RE: Hwy 17 - Royal Oak southbound onramp - Pavement Markings

Attached find Highway design drawings and comments.

I am a daily commuter from the Royal Oak area to downtown Victoria. I am writing to express significant safety concerns about the new pavement markings for the southbound merge lane at Royal Oak. It has always been a tricky on-ramp as it is relatively short and the highway curves as you merge onto it. After the pavement resurfacing this summer, the new pavement markings were recently added. The new lines are solid for a much

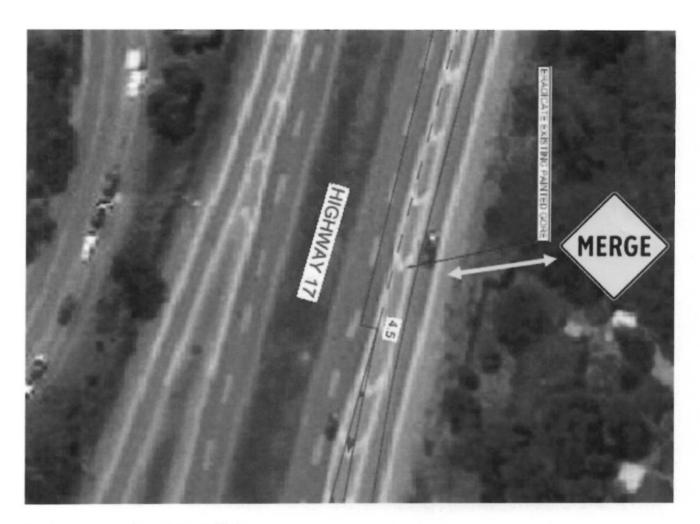
Relocate existing Merge Sign to bring it closer to end of NEW recommended gore markings (field fit- as far as possible

ahead of the merge area):

No change required to existing W37 sign:

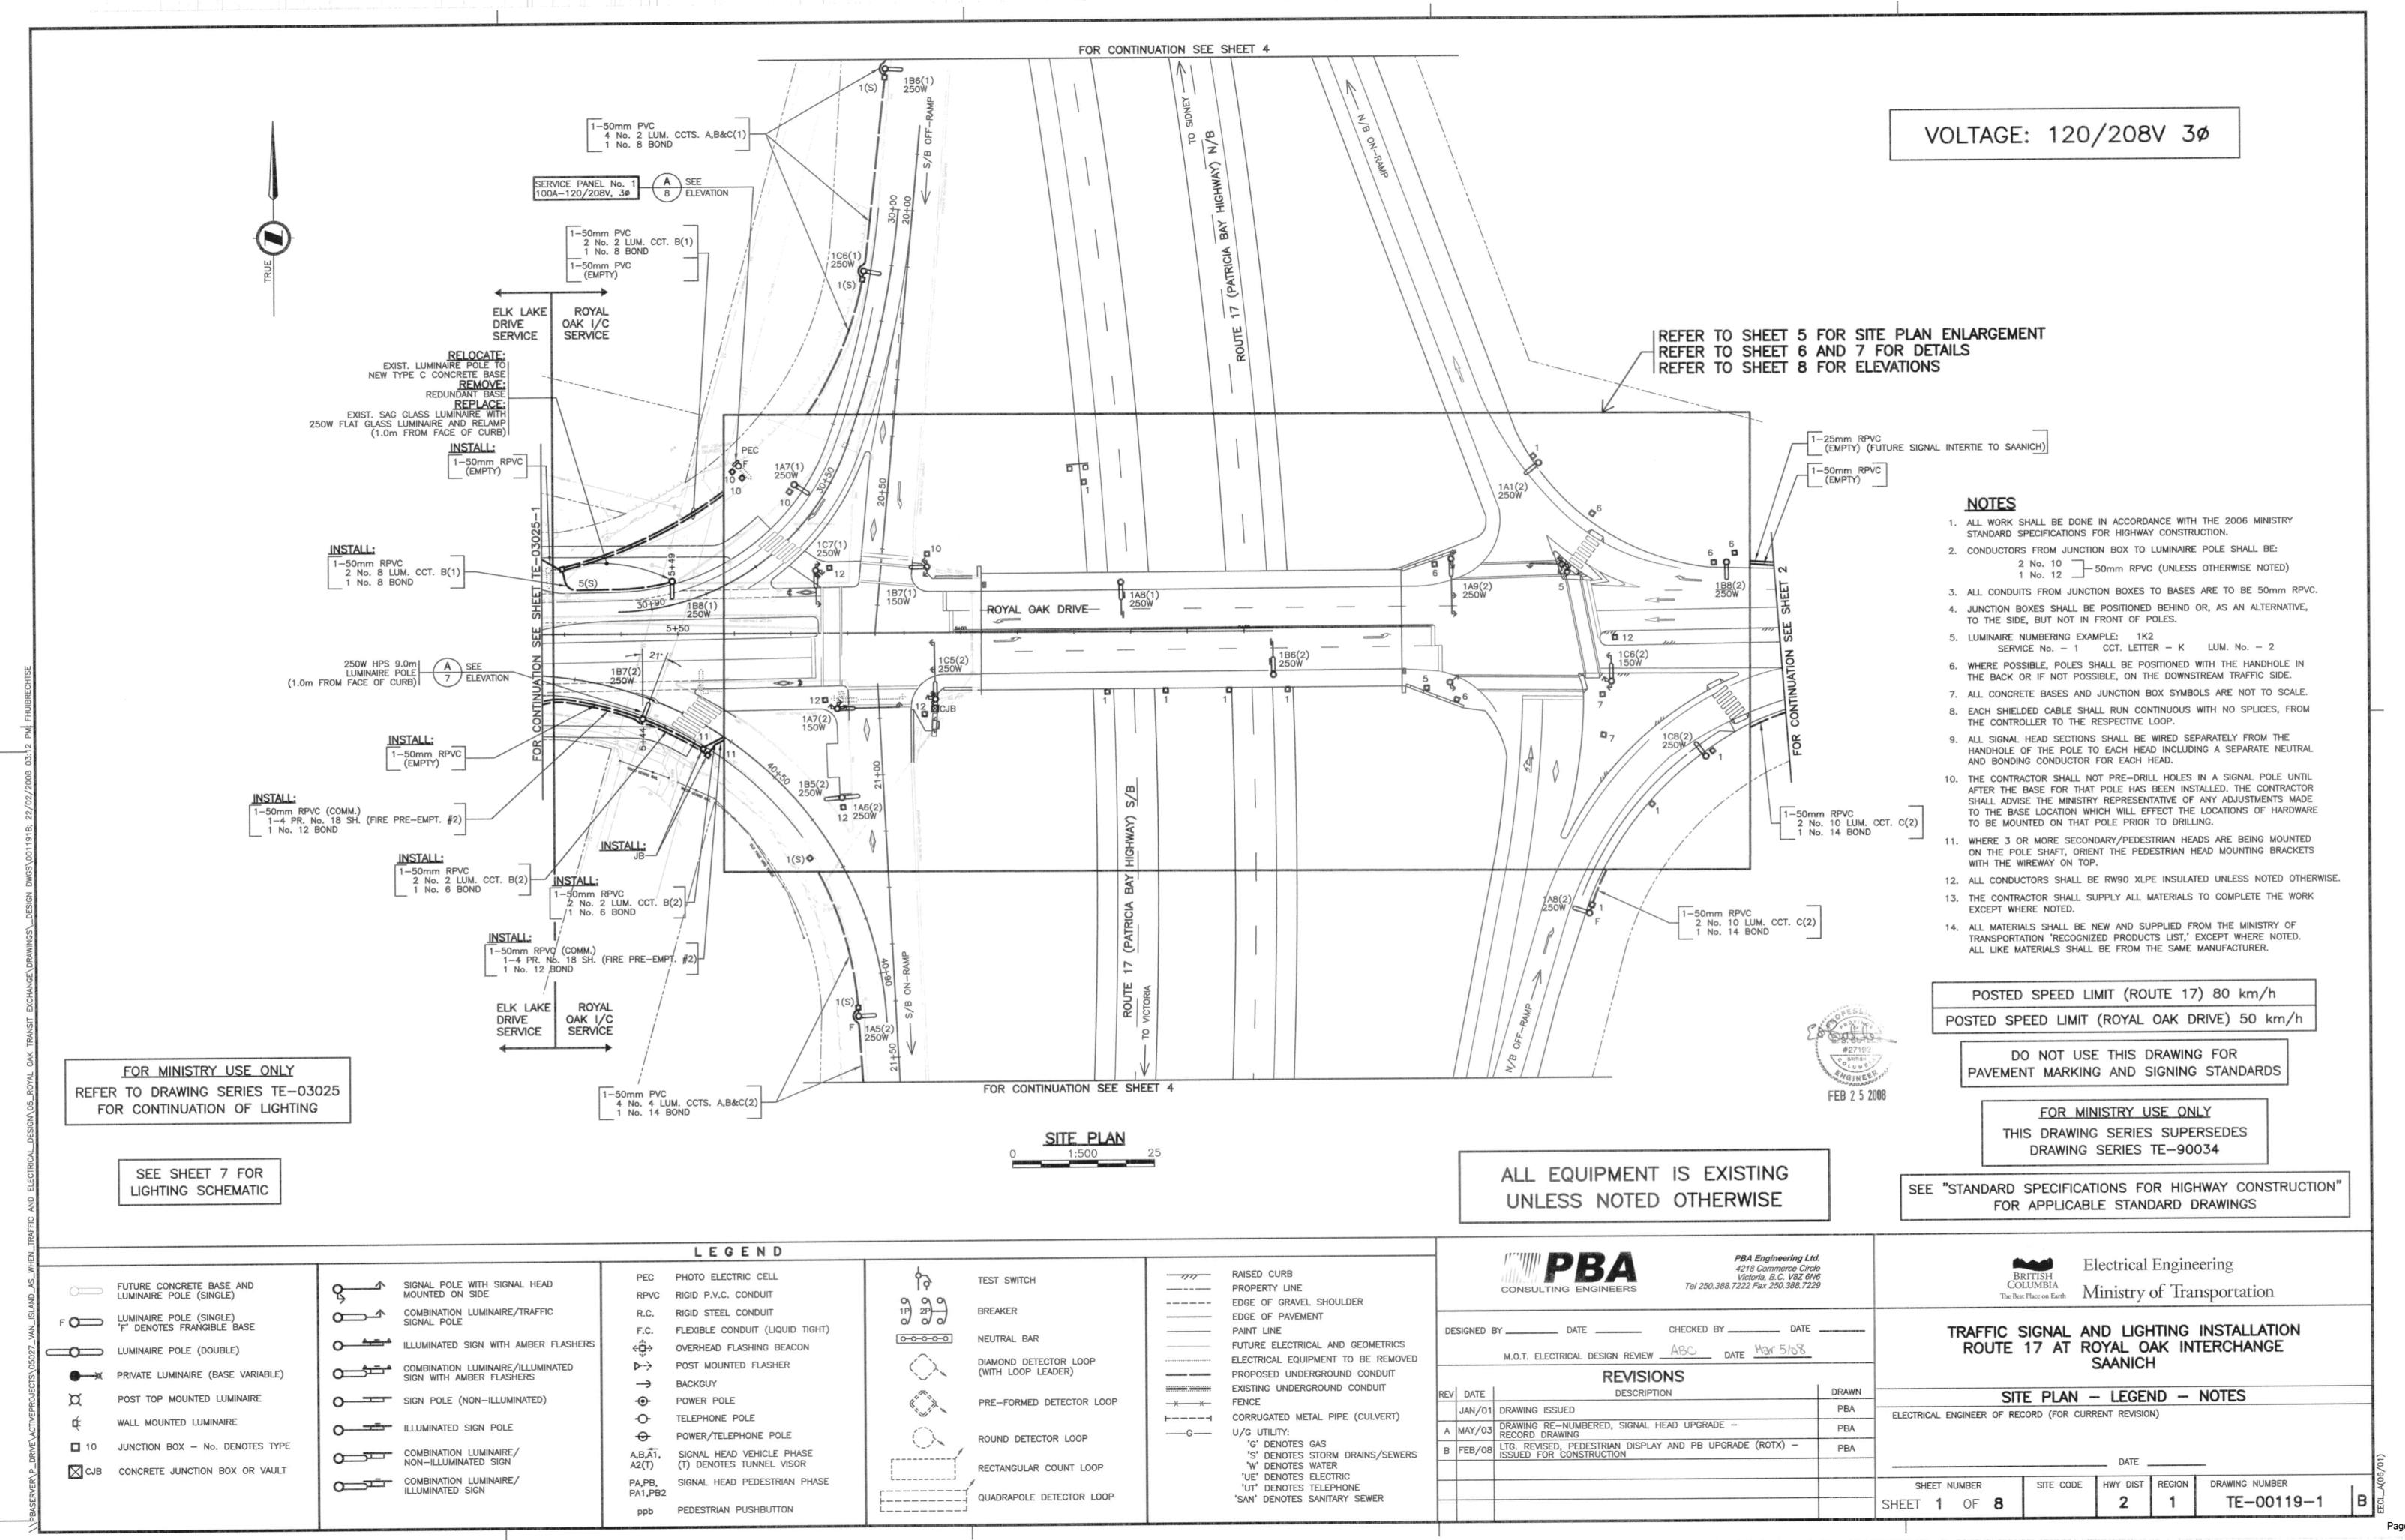
longer length than the prior ones. As a result, the dotted lines don't start until just before the curve of the highway and the merge area is very short. The danger is exacerbated by the concrete barriers placed on the curve on the right side of the highway. All of this means drivers are trying to merge onto a busy highway while also navigating a curve and avoiding the concrete barriers. As a result, to safely merge, drivers are forced to disregard the solid lines and merge onto the highway before the dotted lines begin. This causes confusion and frustration for the drivers already on the highway as they are not expecting vehicles to merge until the dotted line.

Please send an inspector immediately to assess this situation. It is only a matter of time until there is a significant accident.
